2.0 PROJECT DESCRIPTION COMMENTS AND RESPONSES

STATELINE RETAIL CENTER

Figure 2-4: Proposed Overall North Elevation A
Stateline Retail Center
Town of Southeast, Putnam County, New York
Source: DCAK-MSA Architecture
Revision Date: 11/25/08
Scale: As shown

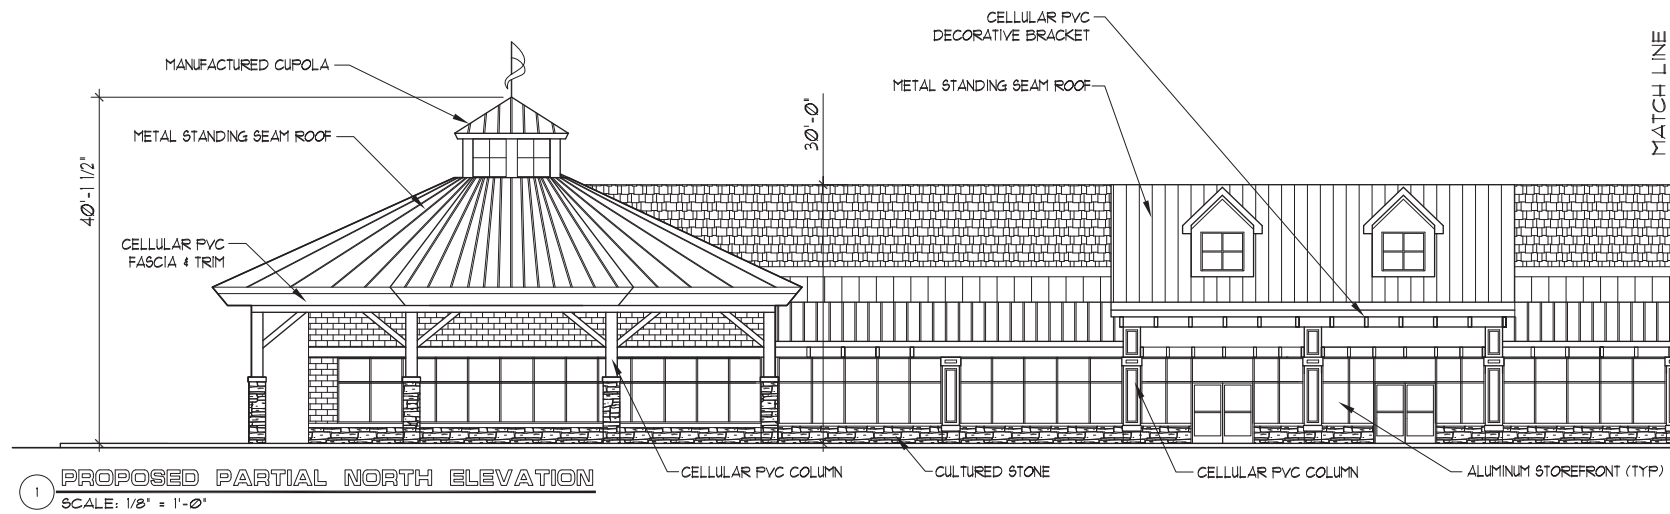
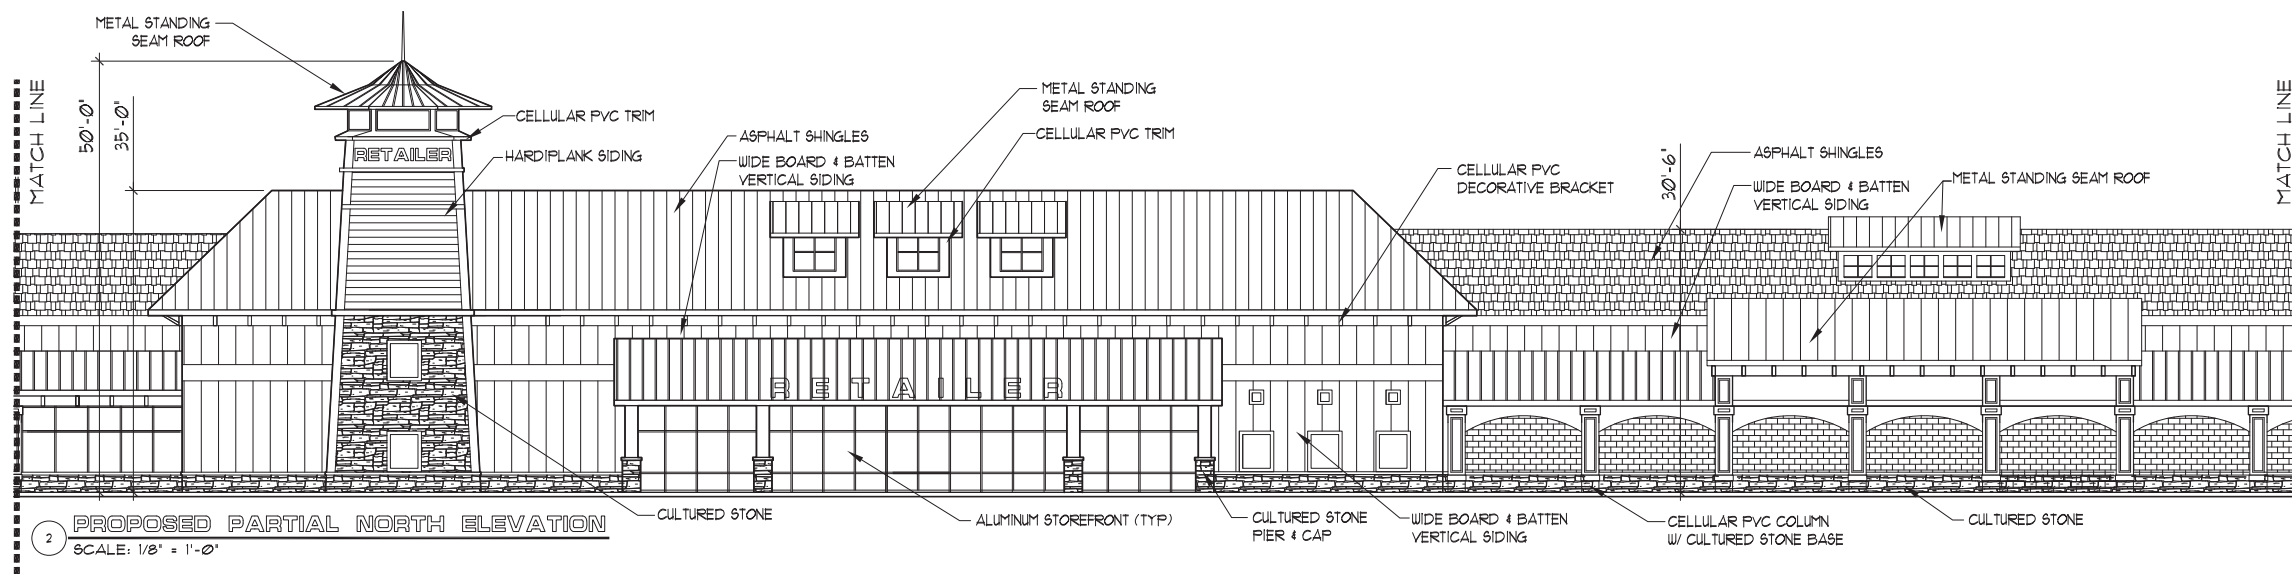
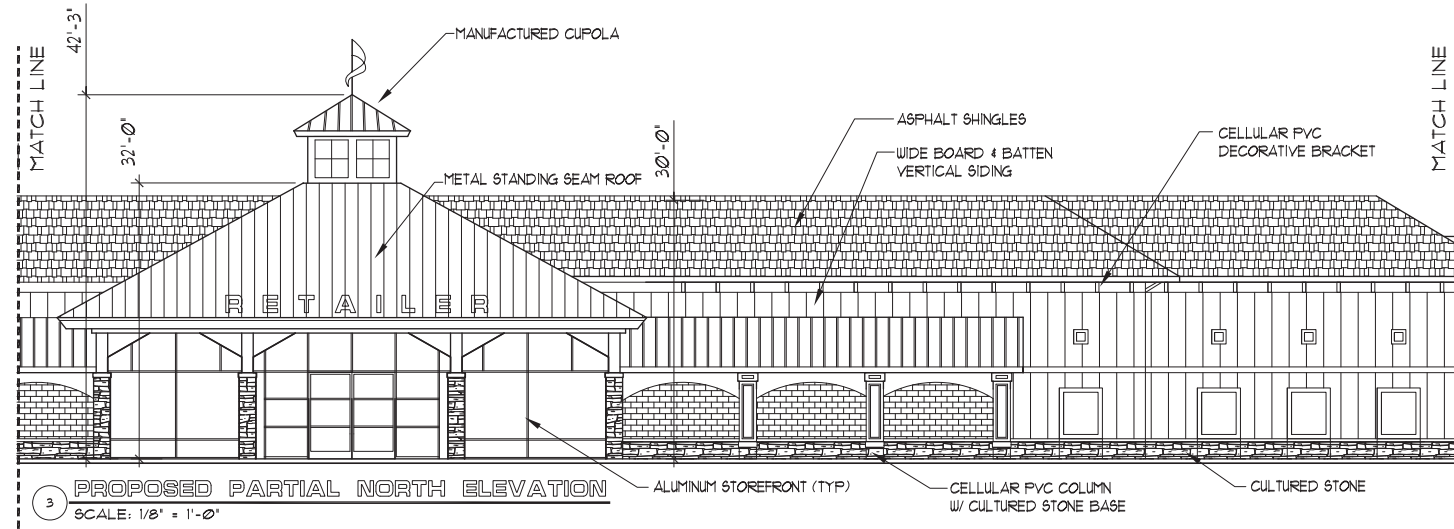
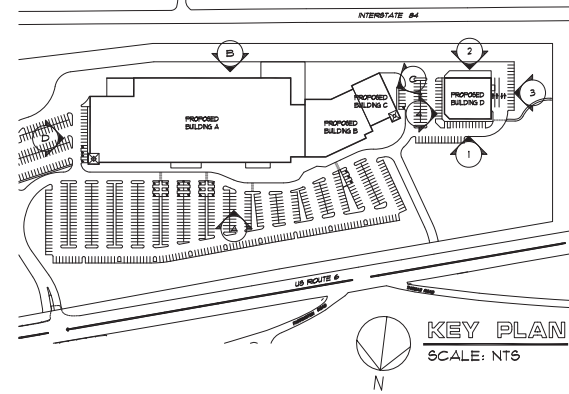
Comment 2.0-9 (Mr. Dan Armstrong, Public Hearing, July 14, 2008): How much latitude is in the overall design? How much [latitude] are they [the tenants] going to have? And that's assuming you don't have tenants when this gets approved. You know, Home Depot or Kohl's is another one where they have a design that they use all over the place, and they will modify slightly. But we're talking here about kind of putting a lot of time into it, into a whole series of elements that may not fit with their image of their store, the corporate image...I don't know how you're going to make all that work with a variety of tenants unless you're going to be able to negotiate with them and say this is it, take it or leave it, because from my understanding, whatever is approved as part of the DEIS or the final EIS, that's what's going to have to be built. This is what you're presenting now but your tenants or whatever, economics makes you, forces you to do something different. **[A similar comment was voiced by Ms. Lynne Eckhart, Public Hearing, August 11, 2008.]**

Response 2.0-9: The modified plan includes a variety of architectural elements that will be incorporated throughout the proposed development; refer to Figures 2-3, 2-4, 2-5,

2-6 and the drawings contained in Appendix D herein for a complete set of building elevations developed by the project architect. Similar to any other Town requirement, the architectural features will be an enforceable element of the project through the new zoning law and conditions set forth in the special permit (Section 138-63.4 of the Town Code).
